HISTORIC AND DESIGN REVIEW COMMISSION

HDRC CASE NO: 2017-109
ADDRESS: 223 W HOLLYWOOD AVE
LEGAL DESCRIPTION: NCB 6459 BLK 10 LOT 10, 11 & E 12.5 FT OF 9
ZONING: R-5 H
CITY COUNCIL DIST.: 1
DISTRICT: Monte Vista Historic District
APPLICANT: Jason Peters
OWNER: Bernice Beck
TYPE OF WORK: Construction of rear storage shed
REQUEST:

The applicant is requesting a Certificate of Appropriateness for approval to build a storage shed in rear of property with materials similar to those found on primary structure.

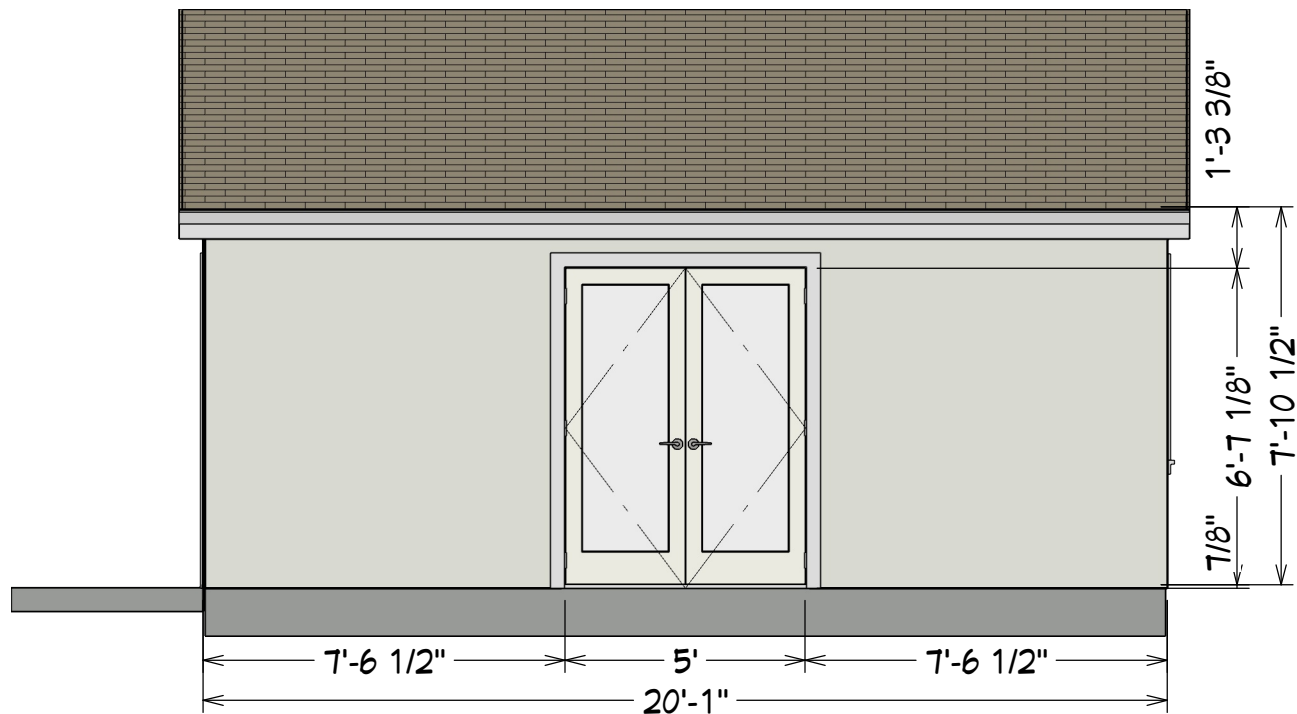
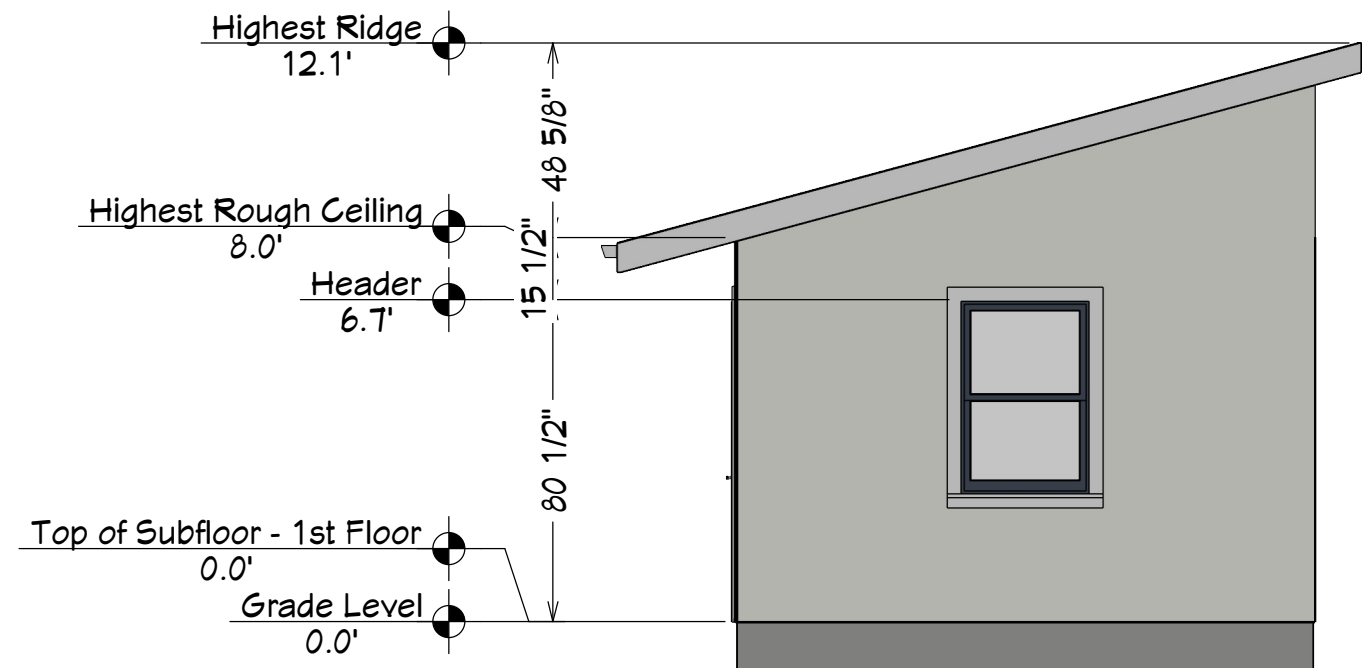
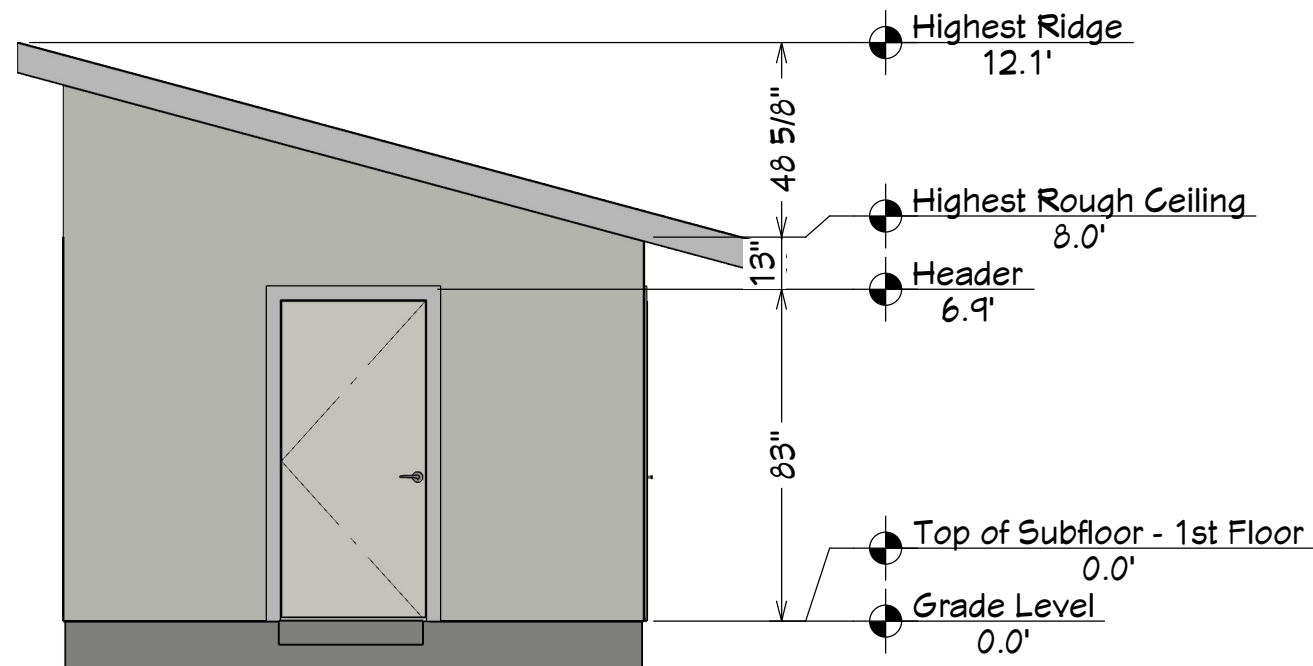
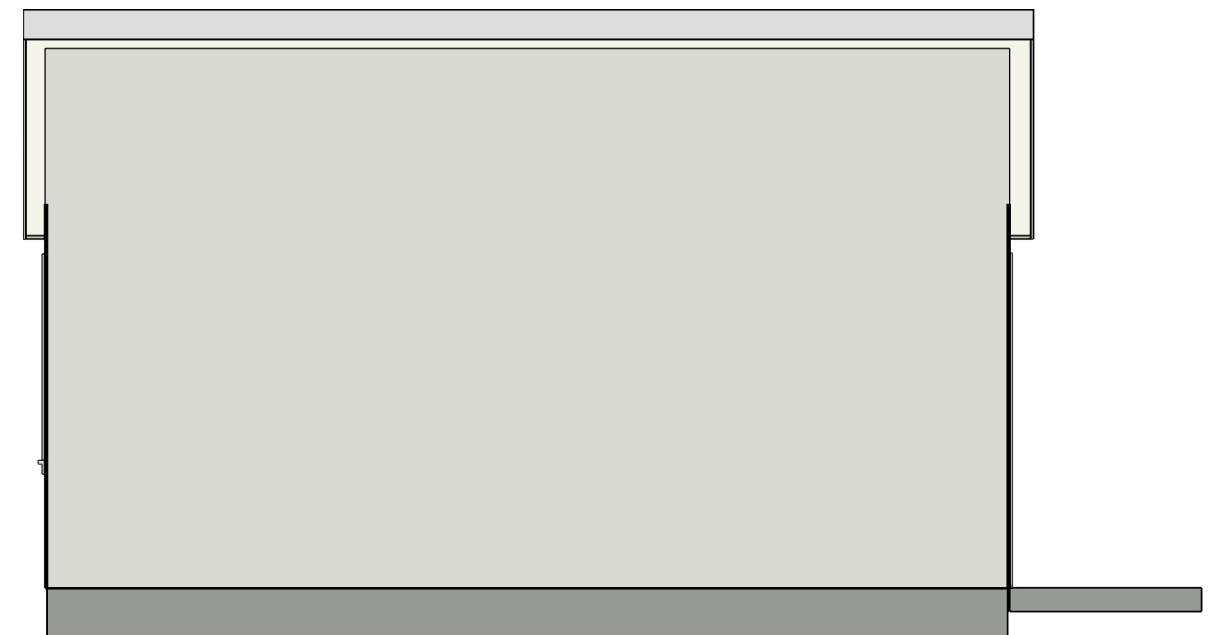
- c. WALL MATERIAL – A new outbuilding should relate to the period of construction of the primary structure through use of compatible materials and simplified details. The primary structure is a contributing structure to the district and its stucco façade is a character defining feature of the design. Staff finds the use of stucco on all four facades of the structure to be appropriate.

- d. WINDOWS AND DOORS – The guidelines for garages and outbuildings recommend materials complementary to the primary structure as well as the district. Staff finds the use of wood windows and doors consistent with the primary structure and the materials of the district.

- e. ROOF – The guidelines state that materials should complement the type, color, and texture of materials traditionally found in the district. Staff recommends that the applicant consider using a roof product that is similar in color to the existing Spanish red clay tile roof on the primary structure.

- i. The applicant submits specifications and manufacturer information for the proposed wood windows and doors to staff for approval.
- ii. The applicant considers using a roofing product that is similar in color to the existing Spanish clay tile roof on the primary structure. The applicant may work with staff to determine the most suitable roofing material and color.
